Appendix A – CCC Engineering Assessment (Miyamoto Cardno)

Subject: Christchurch Cathedral "Make Safe" Prior to Reconstruction

HERITAGE RESPONSE TEAM - HERITAGE BUILDING ENGINEERING ADVICE

Title: CERA MAKE SAFE- PLAN
 Job Name: CHCH CATHEDRAL
 Job #: 108324 SSK#: 023
 Date: 19/10/11 Rev: 1

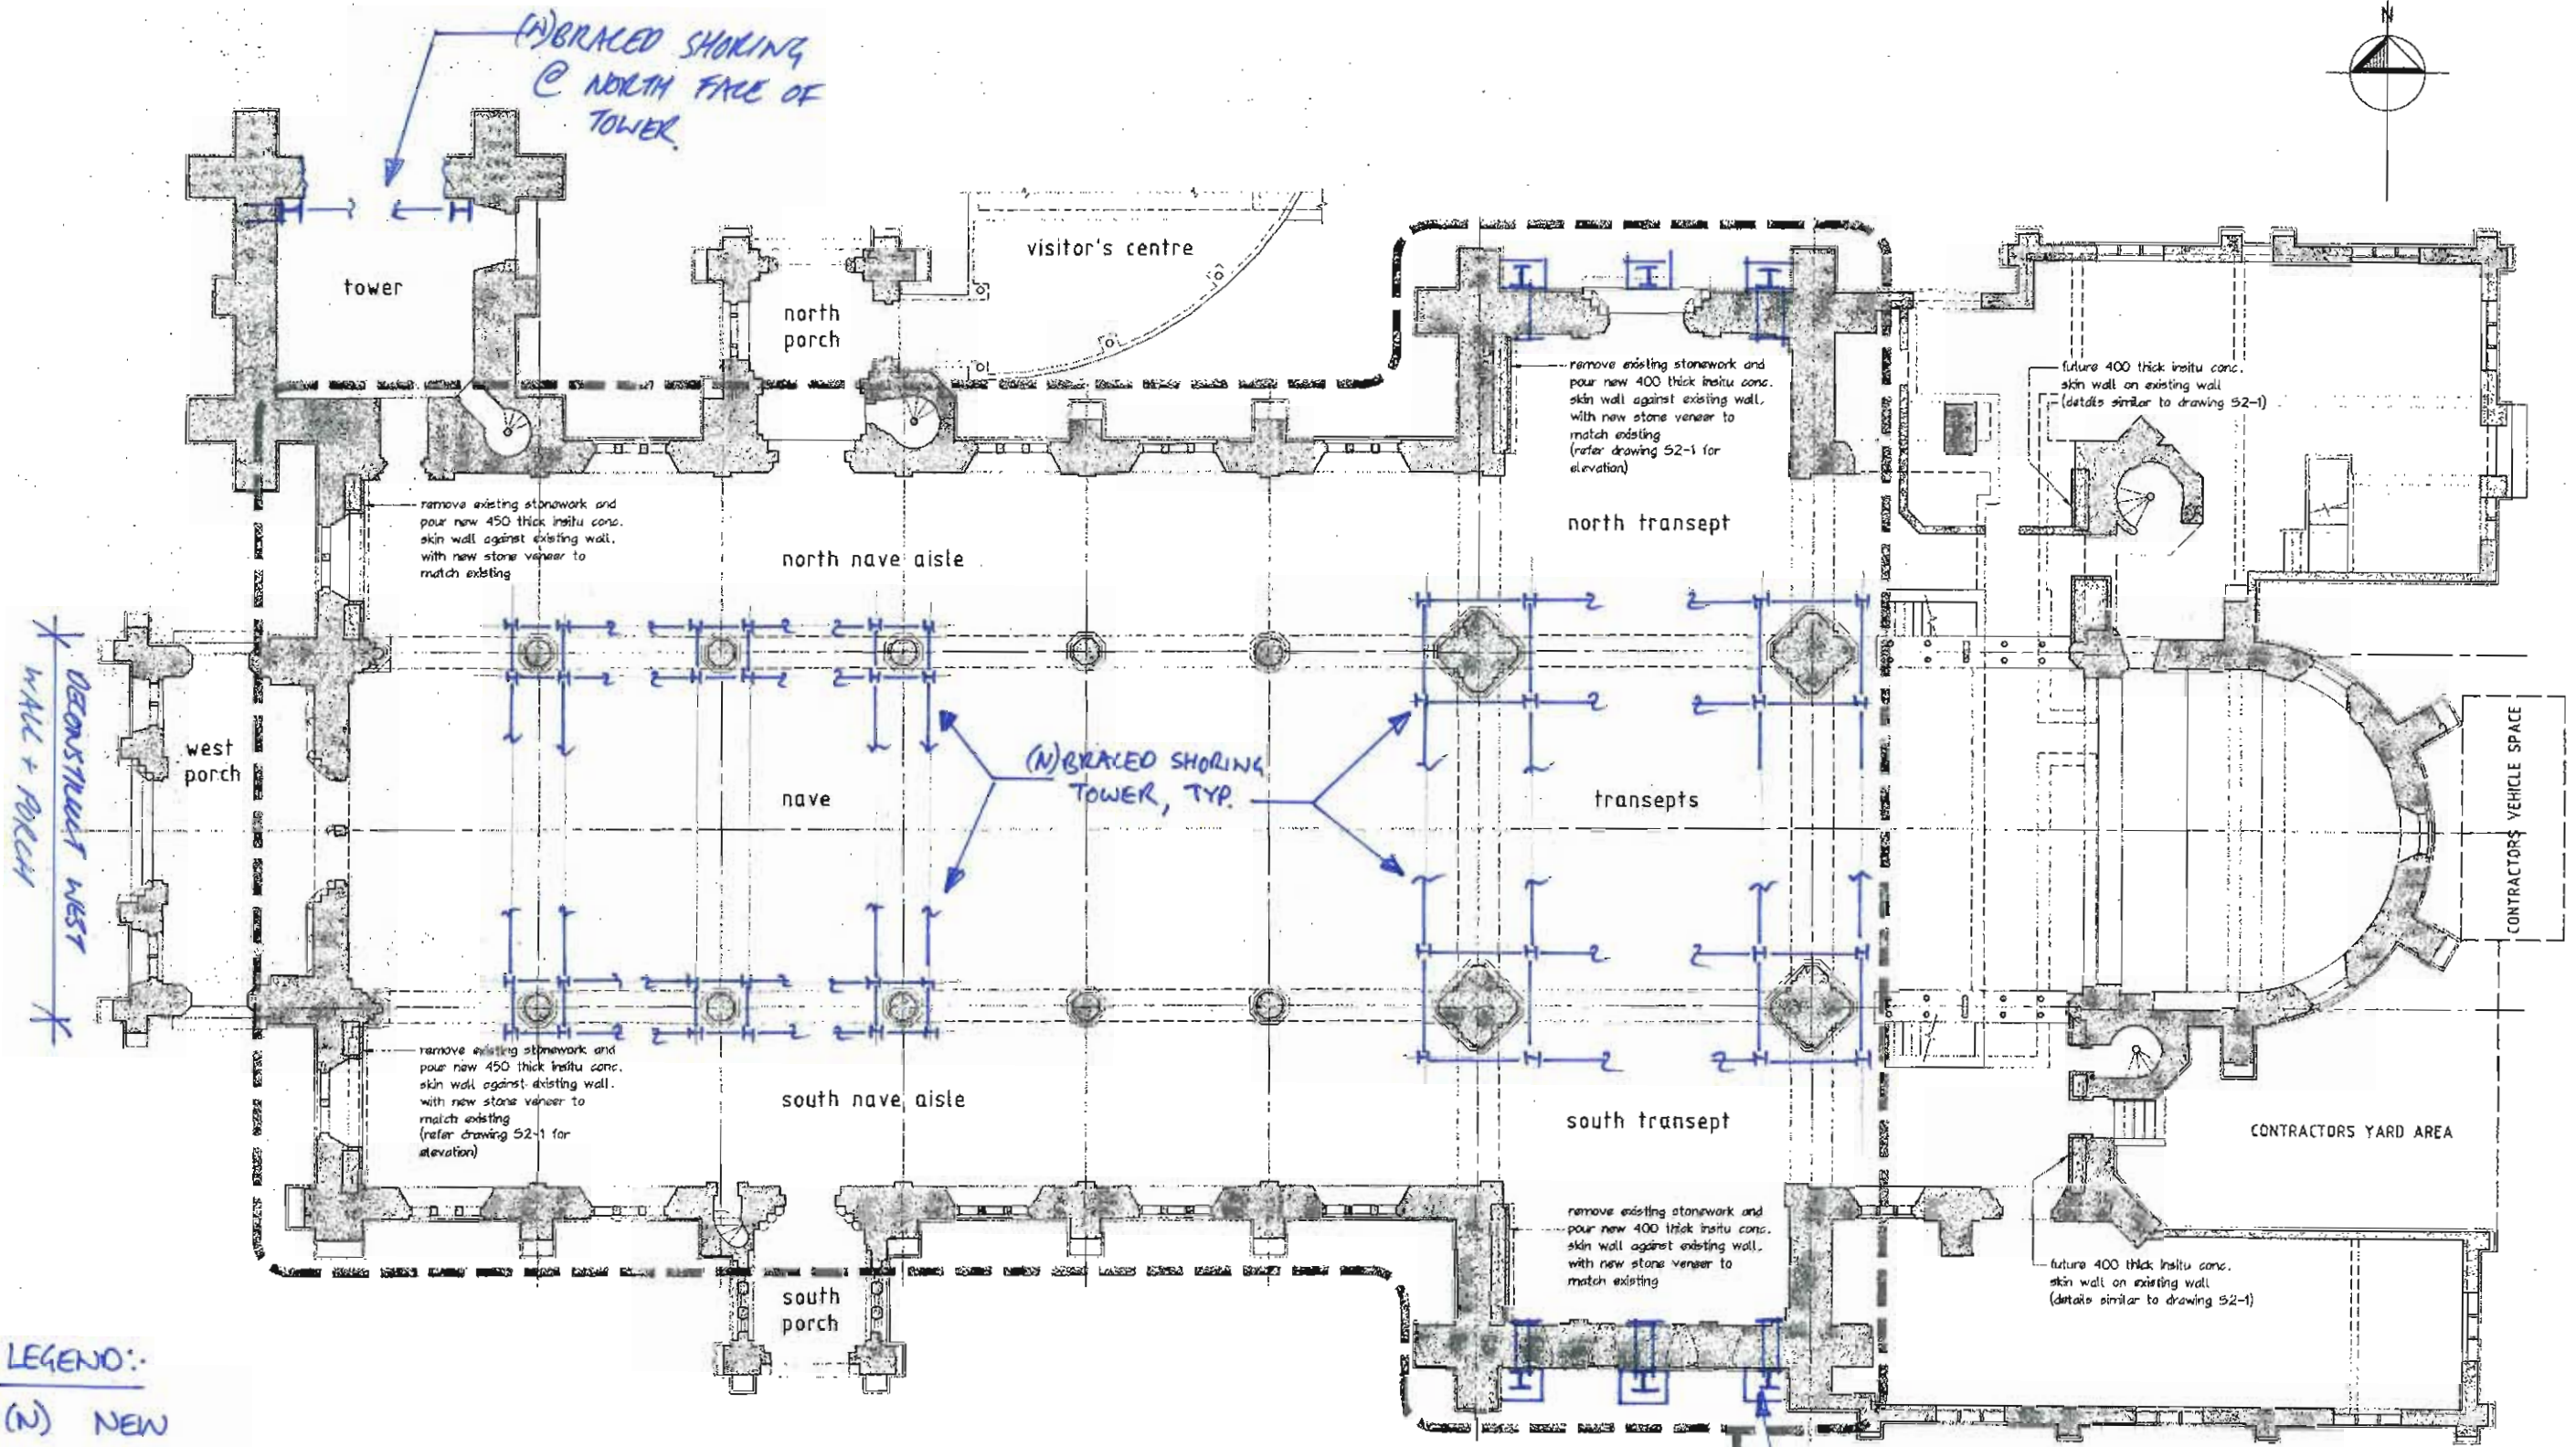
- (i) Braced structural steel shoring towers at the west end of the nave and central transept areas to provide additional global stability to the structure against

- (iii) Vertical steel mullions to provide out-of-plane stability to the north and south transept gables. These gables will be supported at the base by large concrete blocks and tied into the roof at existing roof tie locations.

- (iv) Damaged roof bracing elements will be reinstated. Temporary weatherproofing to replace the area of roof that was damaged by tower debris will also need to be provided.

- (v) Tower to be made safe by providing a new braced shoring frame at the north elevation to replace the lost section of wall. A new concrete 'roof' slab will be provided at the top of the remaining section of tower to maintain structural integrity and provide additional protection against future weathering.

South elevation
(North elevation sim.)

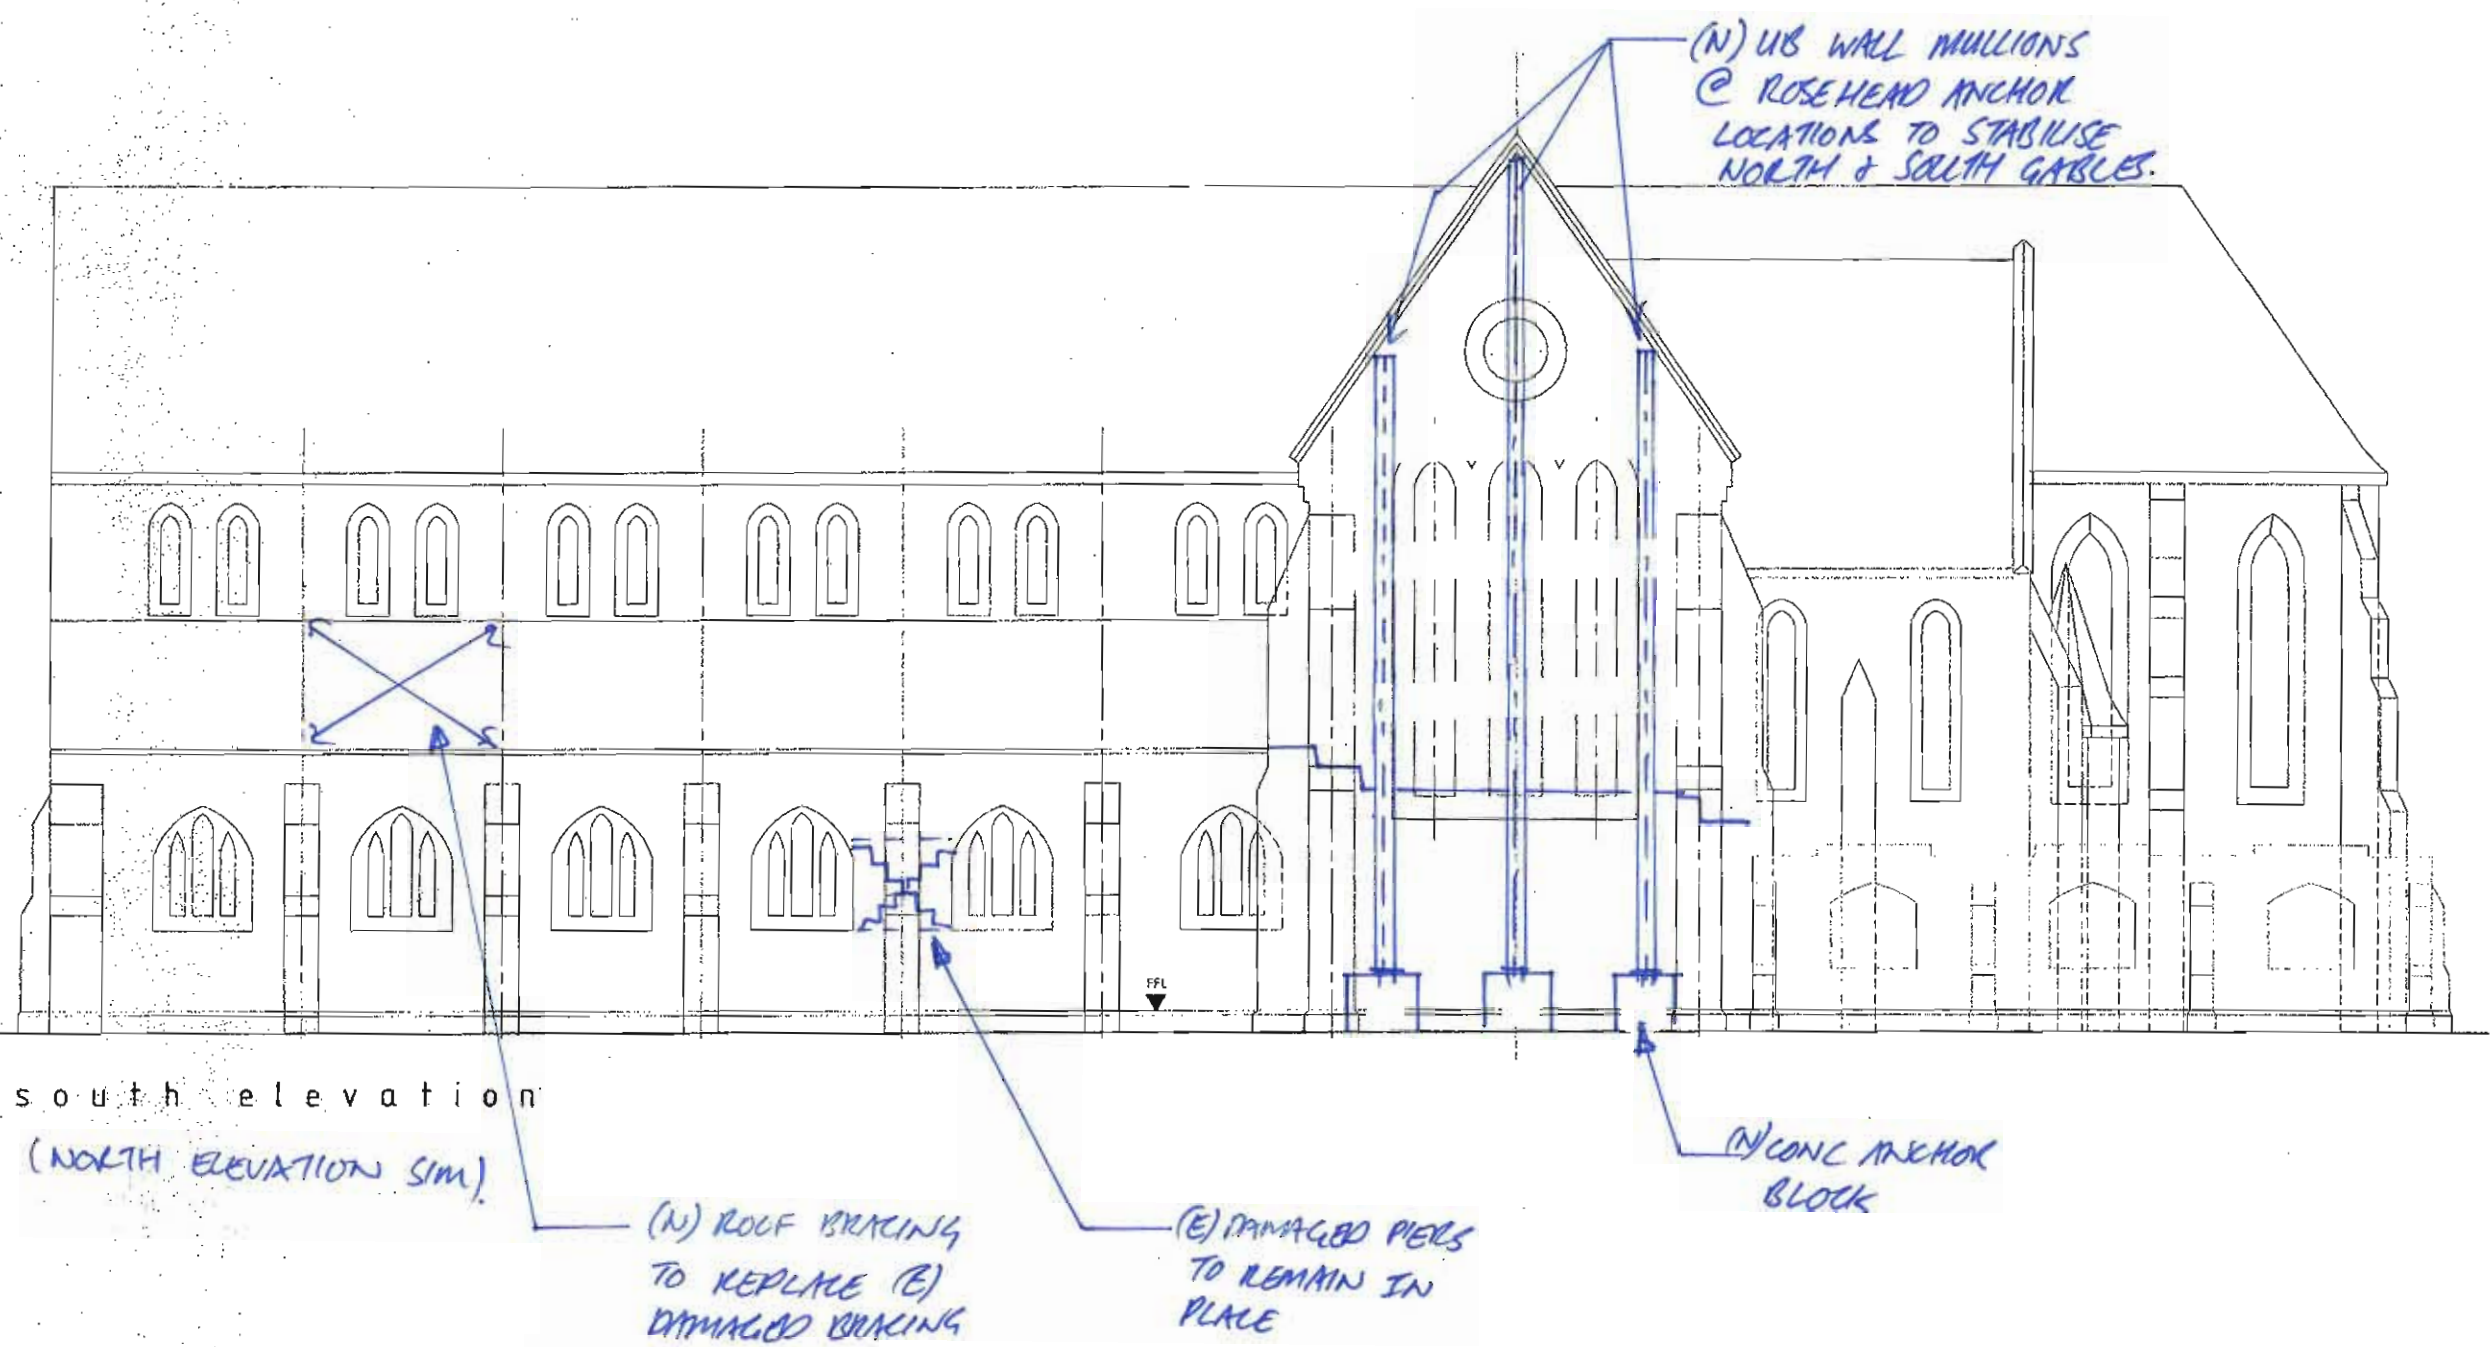
(N) ROOF BRACING TO REPLACE (E) DAMAGED BRACING IN THIS BAY.
